La Jolla Shores Planned District Advisory Board (LJSPDAB) APPLICANT PROJECT INFORMATION FORM

Subject: 8081 Calle Del Cielo, Assessment Letter; Project No. PRJ-1104216
Internal Order/Trust Account: IO: 24009698. La Jolla Community Planning
Association.

Site Development Plans, Akavan Residence, 8081 Calle Del Cielo San Diego, CA 92037, dated July 25, 2024

Site Development Plans PRJ-1104216.pdf

PROPOSED SITE PLAN

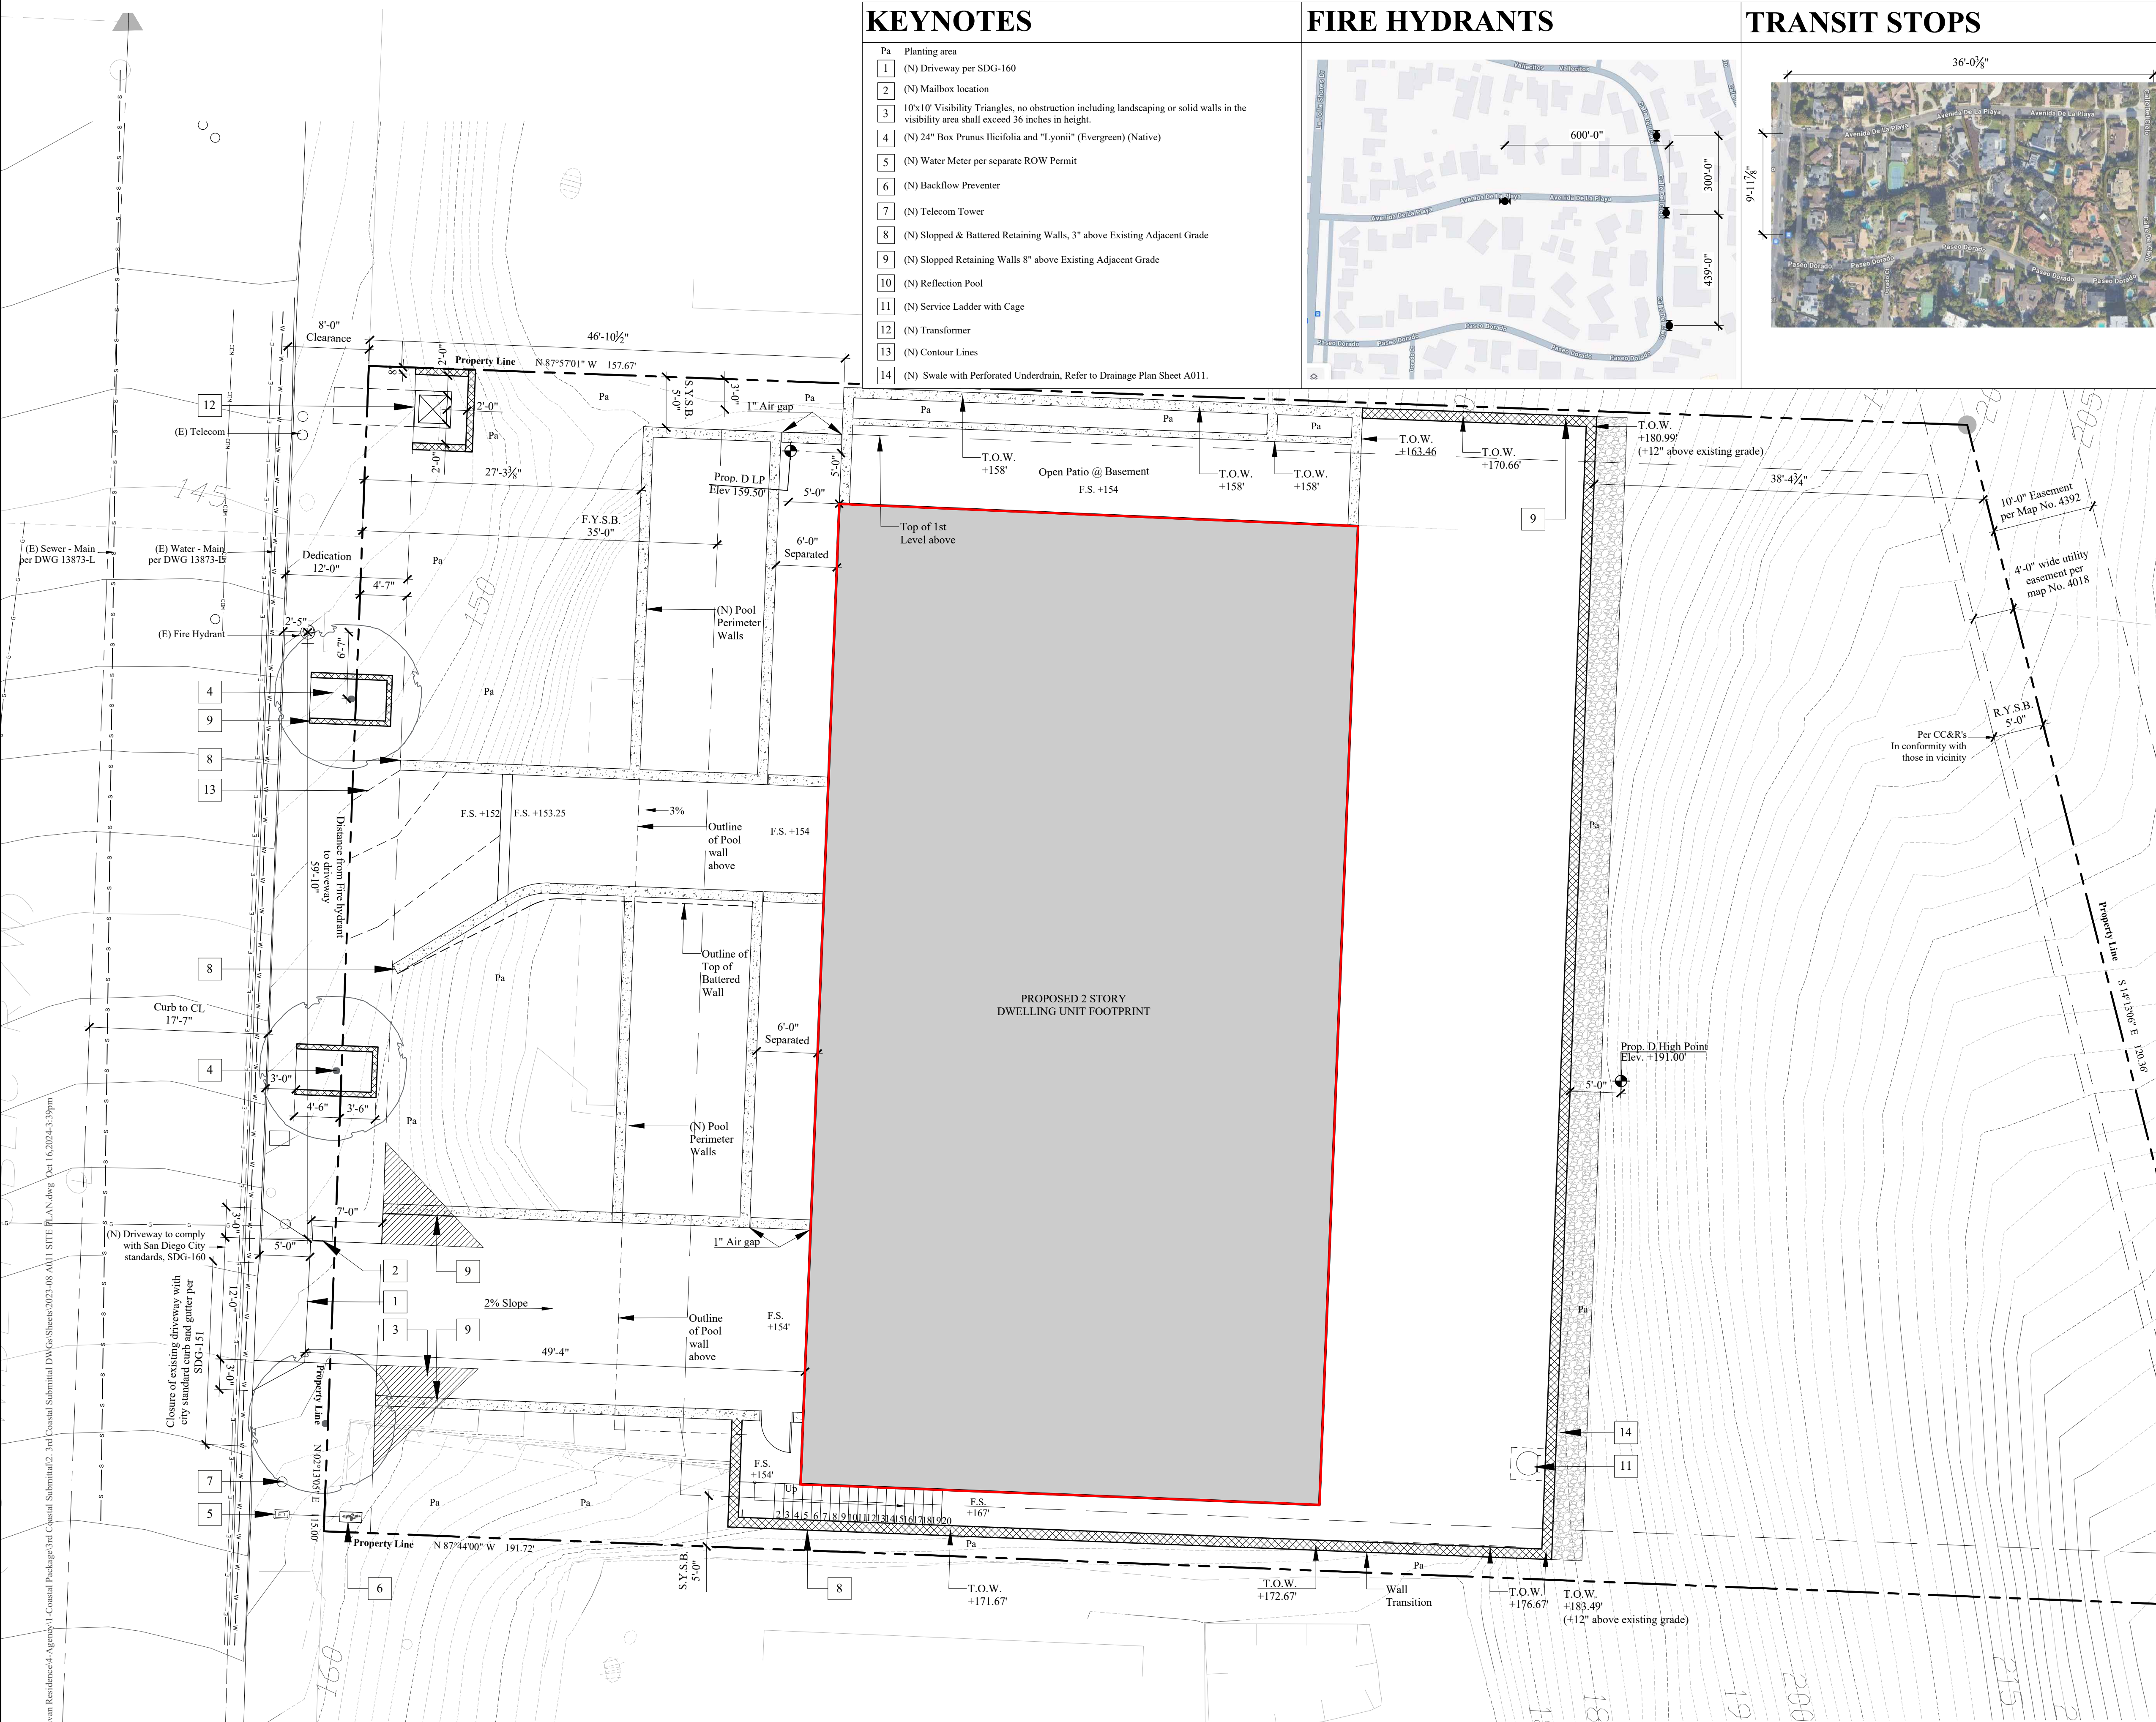
Follow up: Sheet A 012 does not address the need for a storm water quality assessment. A storm water quality assessment addressing the treatment control, HMP, volume retention etc. shall be prepared by a licensed civil engineer.

Follow up: Sheet A 012 does not address the need for a drainage study. A drainage report quantifying the existing and proposed runoff, velocity, capacity, offsite flows, etc. shall be prepared by a licensed civil engineer.

PROPOSED ROOF PLAN

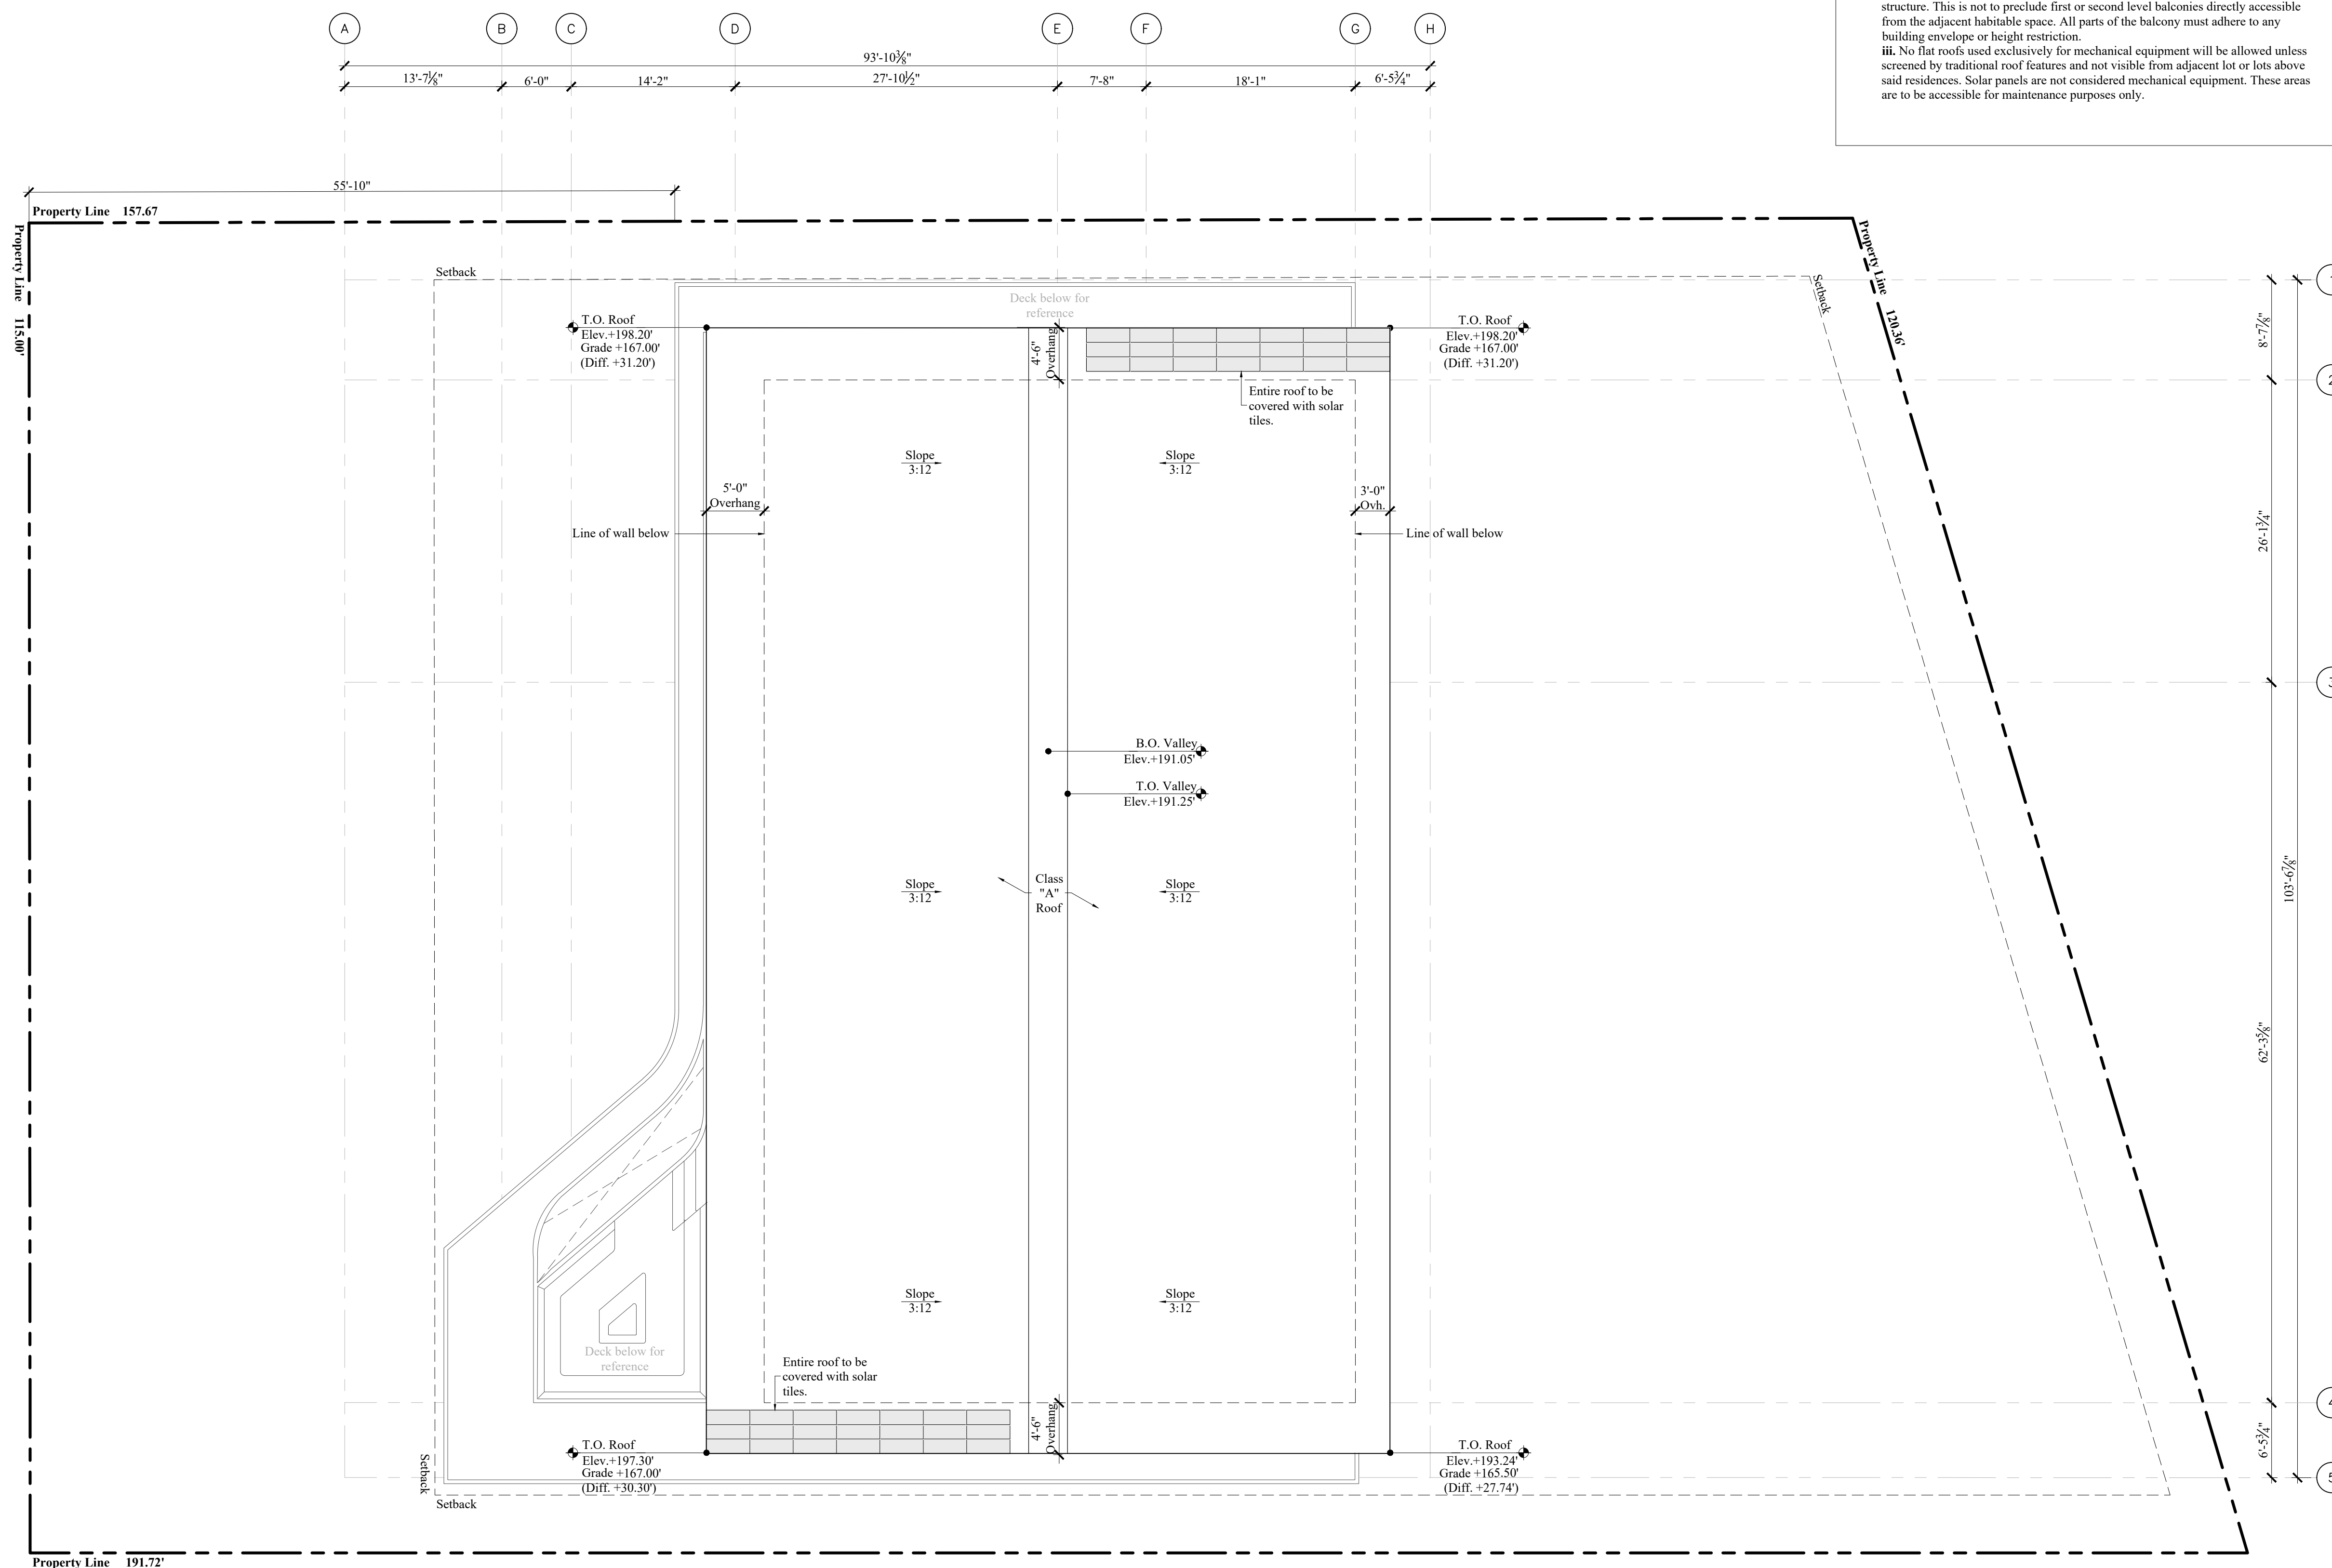
Upon resubmittal please include a roof plan with spot elevations.
